DEFENSE NUCLEAR FACILITIES SAFETY BOARD

May 9, 1996

**SAFETY OF HEPA FILTER UNITS IN HANFORD
B-PLANT EXHAUST VENTILATION SYSTEM**

**SAFETY OF HEPA FILTER UNITS IN HANFORD
B-PLANT EXHAUST VENTILATION SYSTEM**

Figure 1

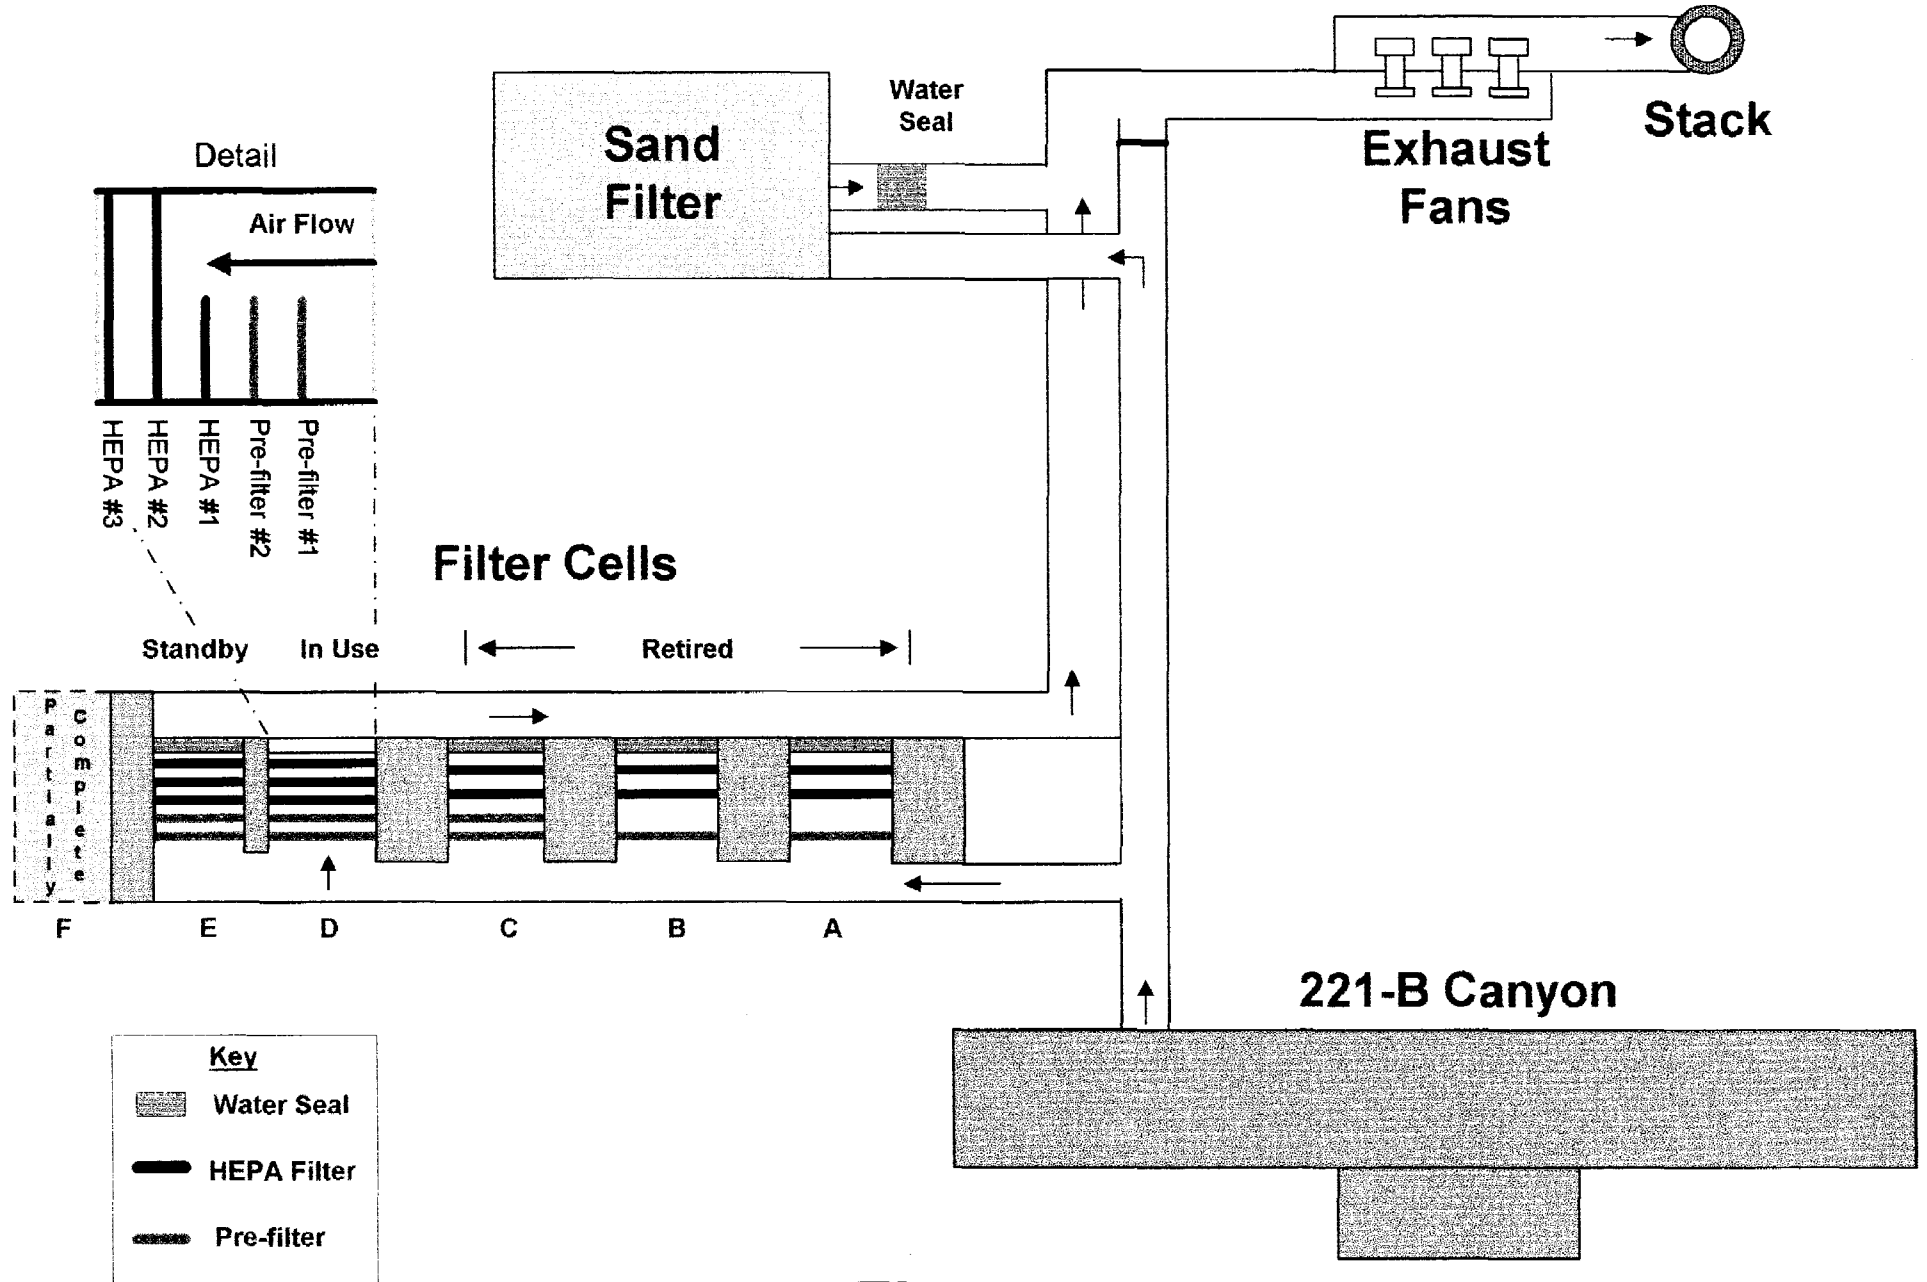
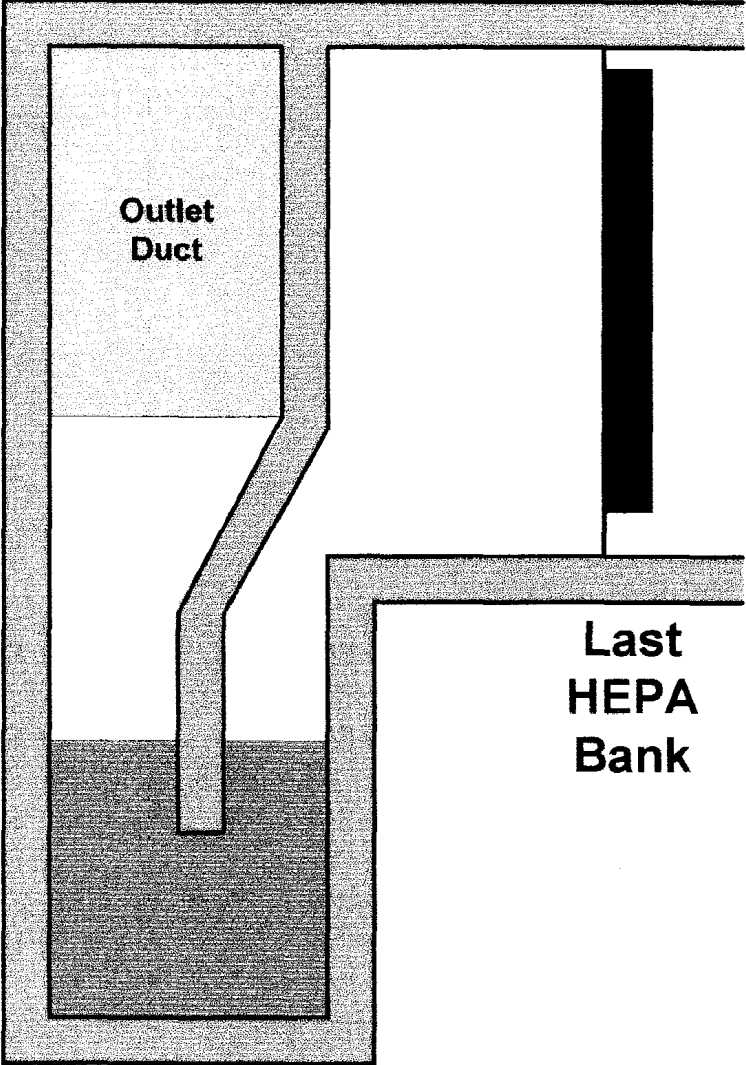
The current differential pressure drop across the last HEPA filter bank (Filter #3) is approximately 0.42 inch of water column, whereas the differential pressure across the other operating HEPA filter bank (Filter #2) is approximately 0.35 inch of water column. The detail on Figure 1 depicts the various filter banks. Based on the data, there is either a problem with the instrumentation or the first HEPA filter bank (Filter #2) is operating at less than acceptable performance. Based on operating experience, one would expect the downstream HEPA filter bank (Filter #3) to have a lower differential pressure than the upstream HEPA filter bank (Filter #2) because of the increased loading on the upstream HEPA filters. Additionally, the differential pressure across Filter #2 is less than that expected for a new HEPA filter, while the differential pressure across Filter #3 is greater than that expected for a new HEPA filter. This could mean that Filter #3 is slightly loaded and that Filter #2 has experienced localized breakthrough.

WHC speculates that the flow path around the bypassed filters (pre-filters and HEPA Filter #1) creates a flow pattern such that there is a nonuniform flow (i.e., nonuniform air velocities upstream of HEPA Filter #2) that could influence the static pressures measured by the instrumentation. However, it appears more likely that the lower differential pressure across Filter #2 is due to localized breakthrough of the filter that would result in a lower flow resistance and a lower differential pressure. The breakthrough is most likely localized based on the Filter #2 differential pressure measurements and the results of the filter

Figure 2

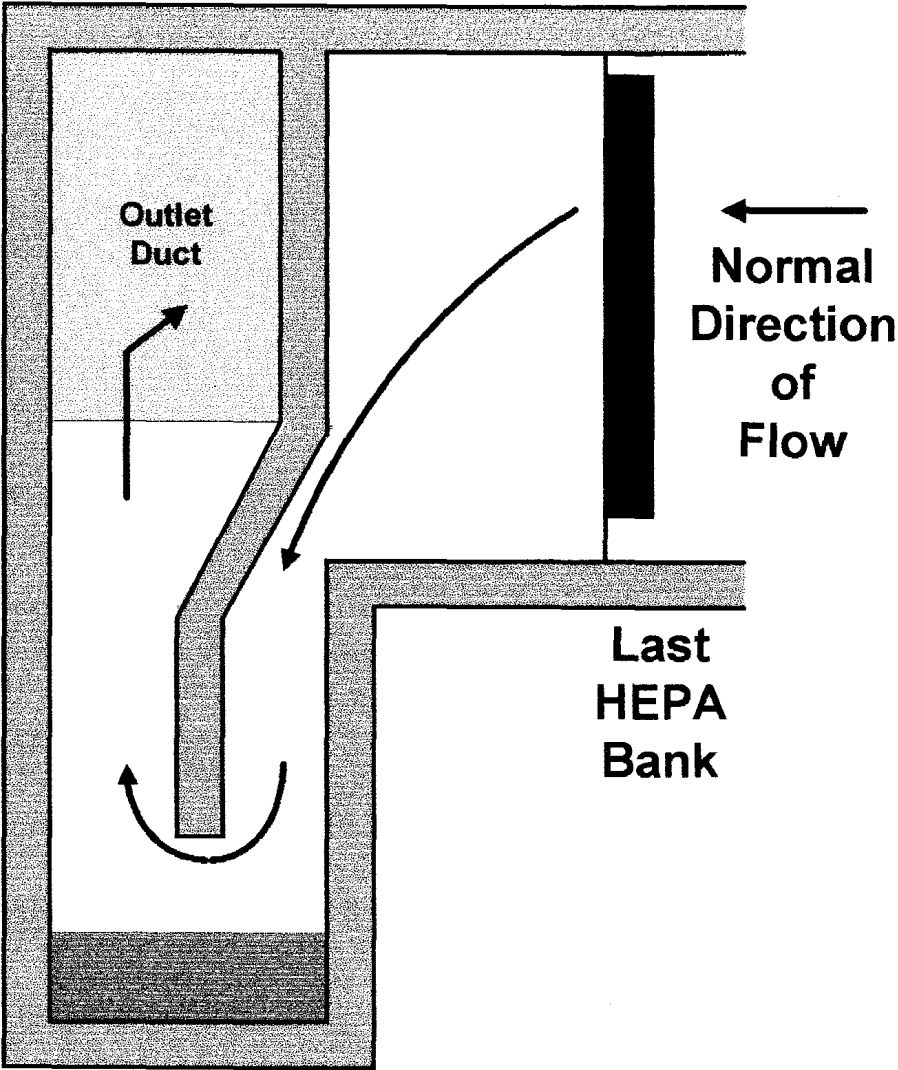
Although water seals may be appropriate for remotely operating inaccessible filter units, they do not provide a reliable long-term isolation function for retired or deactivated filter units. The water seals were not designed to meet single failure criteria and could be subject to inadvertent rapid draining (e.g., steam jetting) or gradual draining (e.g., evaporation, leaks). The water seals are also subject to overfilling that can flood the filter cells and wet the HEPA filters, which would further degrade the integrity of the filters. The flooding can also provide another mechanism for transport of radionuclides from the HEPA filters to the environment. As noted in Appendix A, retired filter units have been inadvertently flooded on two occasions.^{22,23,24}

In the past, WHC had considered various alternative schemes for isolating HEPA filters, including grouting and use of a nonvolatile liquid or foam material. All of these alternatives were rejected, and there are no near-term plans to replace the water seals. Leaving the outlet water seals of the retired filter units in their present configuration for several more years does not appear to be prudent. It appears that additional effort is warranted to identify an alternative that would provide enhanced reliability and not adversely impact future remediation of the filters. For example, the suitability of using a fine sand should be analyzed. The sand could be pneumatically and remotely substituted for the water, would be temporary, and would not be susceptible to inadvertent jetting.
